ADDENDUM NO. 1

Water, Sewer, paving, Drainage, and Street Light Improvements to serve
South Oak Grove Estates, Section Six
CITY PROJECT NO.: 102739

Bid Date: January 14, 2021
Addendum No. 1: Issued January 8, 2021

SANDALWOOD DRIVE PLAN AND PROFILE

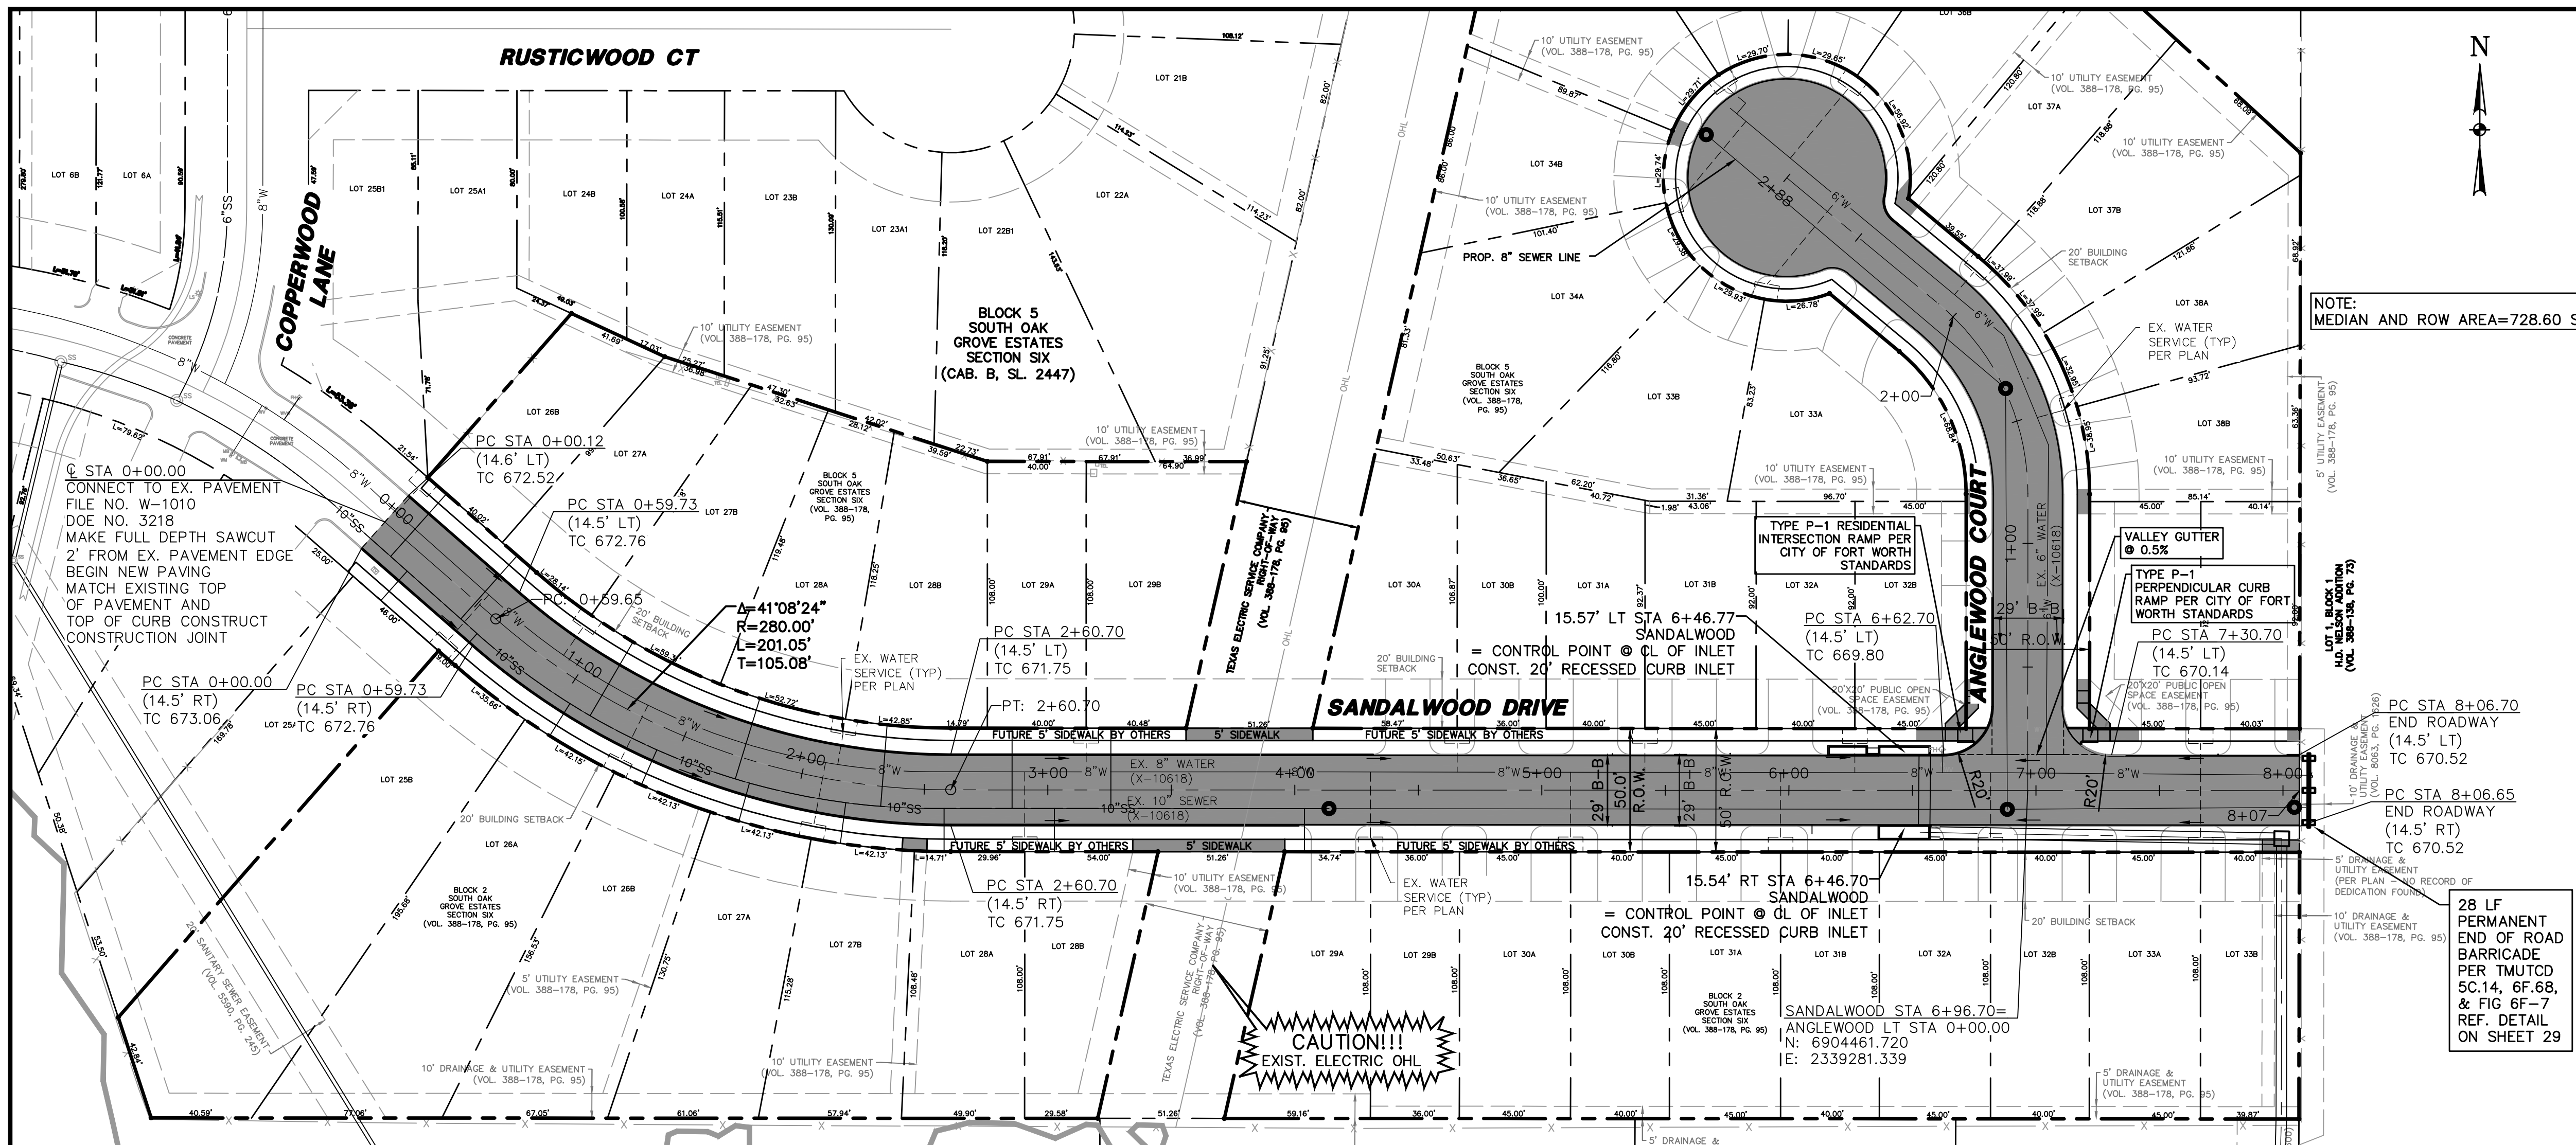
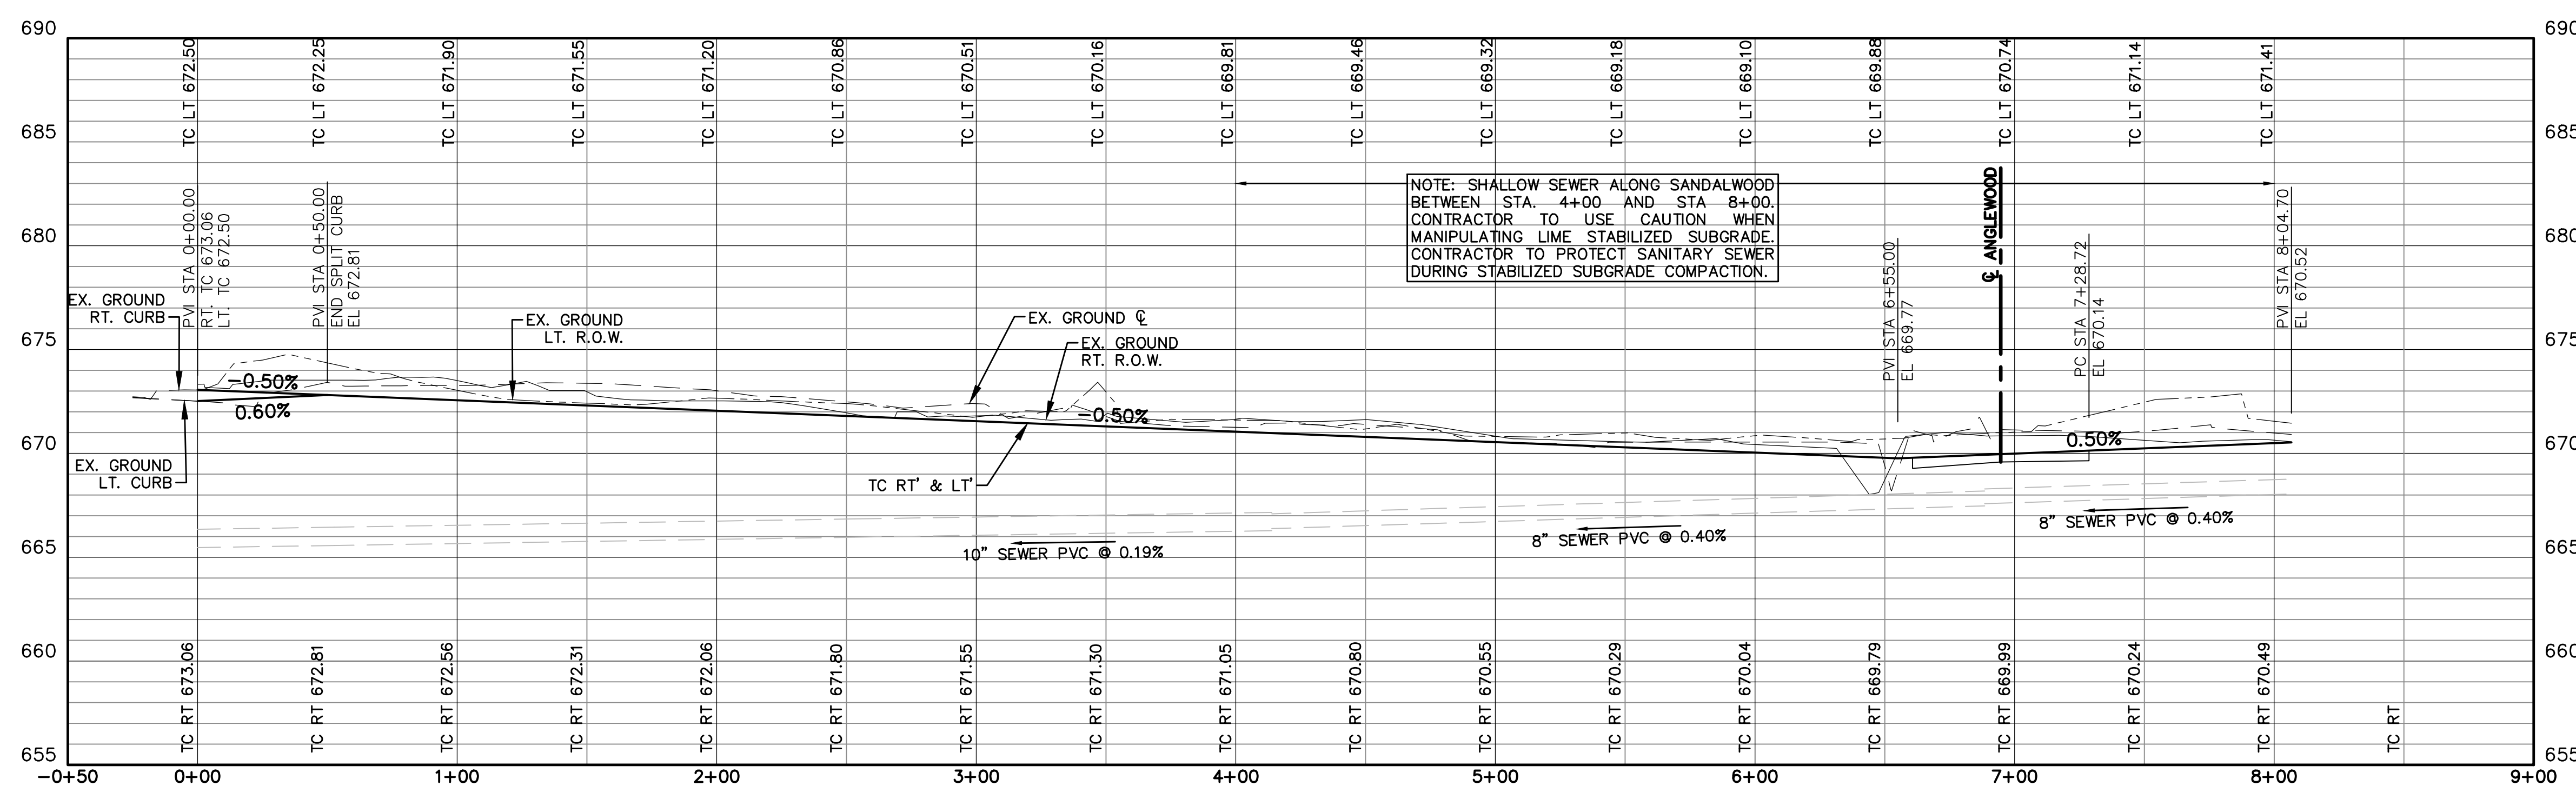
Sheet 21	Modified the lime stabilization construction note.
Sheet 27	Modified contraction joint spacing.

NOTE: SHALLOW SEWER ALONG SANDALWOOD BETWEEN STA. 4+00 AND STA. 8+00. CONTRACTOR TO USE CAUTION WHEN MANIPULATING LIME STABILIZED SUBGRADE. CONTRACTOR TO PROTECT SANITARY SEWER DURING STABILIZED SUBGRADE COMPACTION.
